*Re: Addendum to Final Regional Water Supply Facilities Plan Report - Hidalgo County, Texas
TWDB Contact No. 0804830848*

**ADDENDUM TO
REGIONAL WATER SUPPLY FACILITIES PLAN
FINAL REPORT (DATED APRIL 2011)**

To: Connie Townsend, P.E.
From: Deren Li, PhD, P.E., D.WRE, CFM
Date: May 20, 2011
Re: Responses to TWDB Review Comments on Final Report of Regional Water Supply Facilities Plan (April 29, 2011)
TWDB Contract No. 0804830848

Figure 1-1. Hidalgo County and Hidalgo County Drainage District No.1

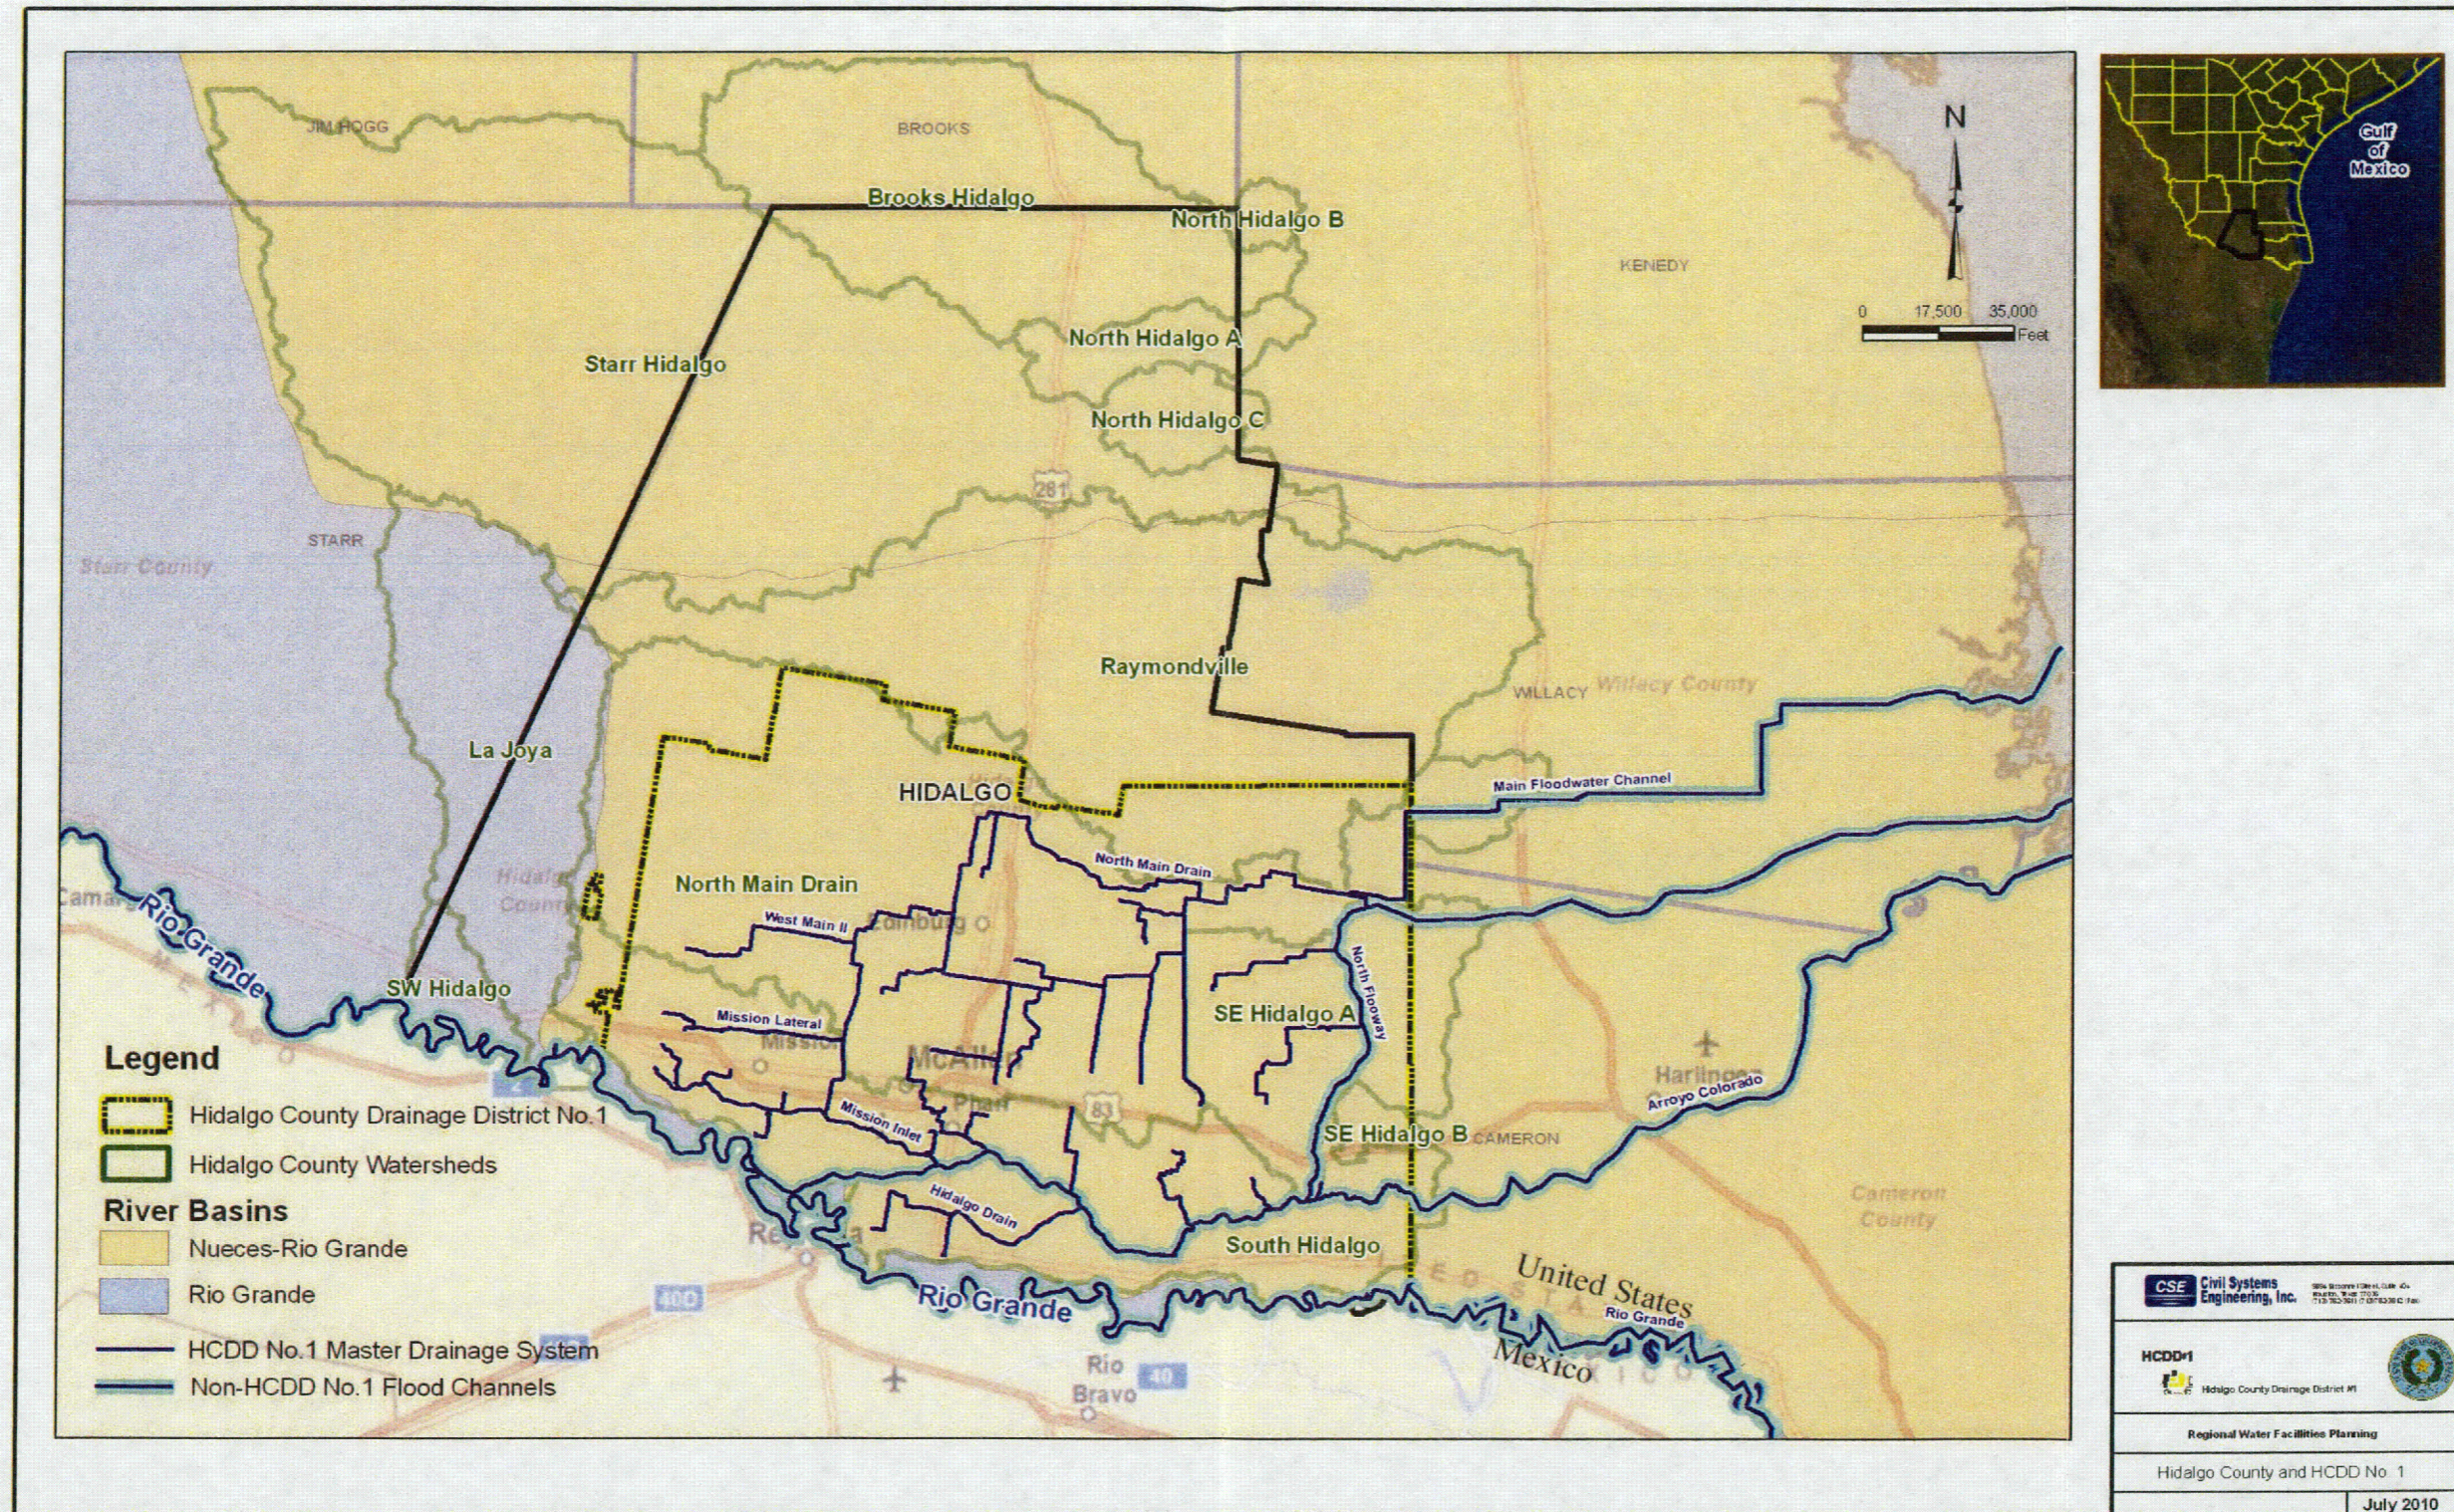
5. *Page 1-4, Figure 1-1: It appears that delineation is missing between district-owned drainage canals and the floodway canals owned by the IBWC and others. In the final report, please identify these other drainage networks separately and add to the figure legend.*

Response: The report Figure 1-1 has been updated accordingly to distinguish between HCDD No. 1 and non-HCDD No.1 streams.

Figure 2-1. North Main Drain Drainage Basin Delineations

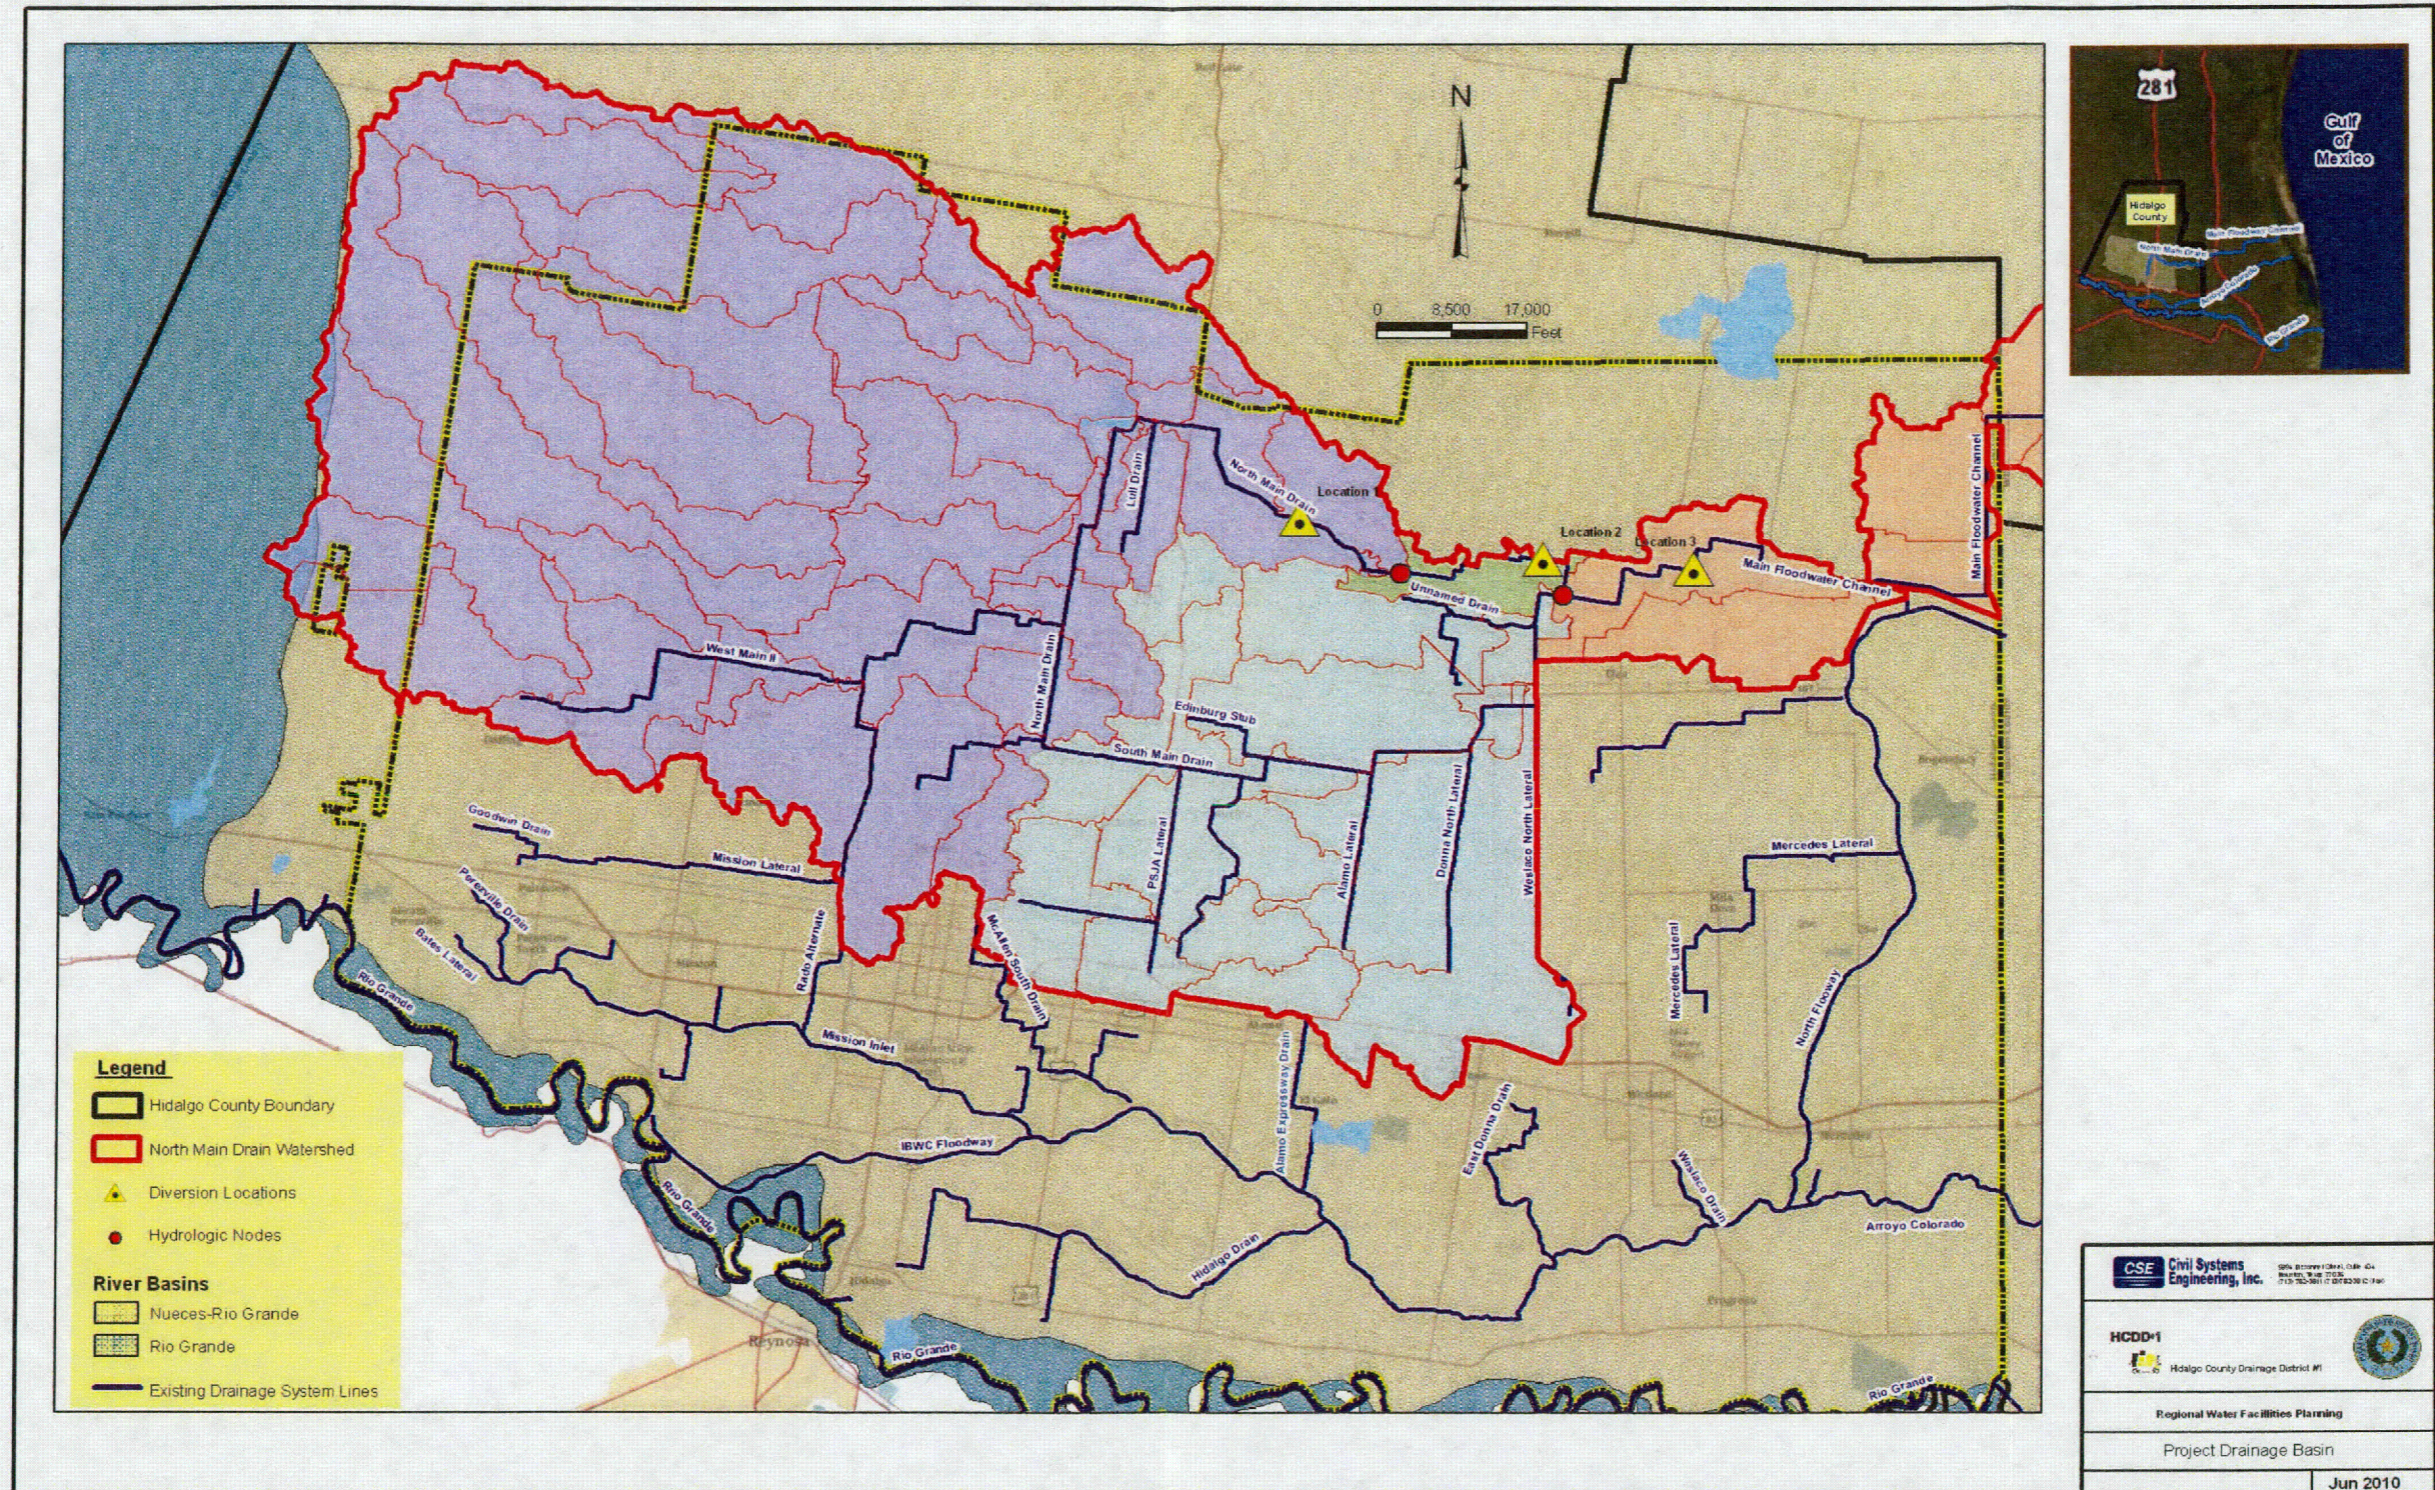
8. *Page 2-2, paragraph 2; Figure 2-1; and Page 3-4, paragraph 2: Please provide the actual square mileage of the North Main Drain Watershed and the percentage of this area that would likely be able to contribute rainfall runoff for stormwater flows.*
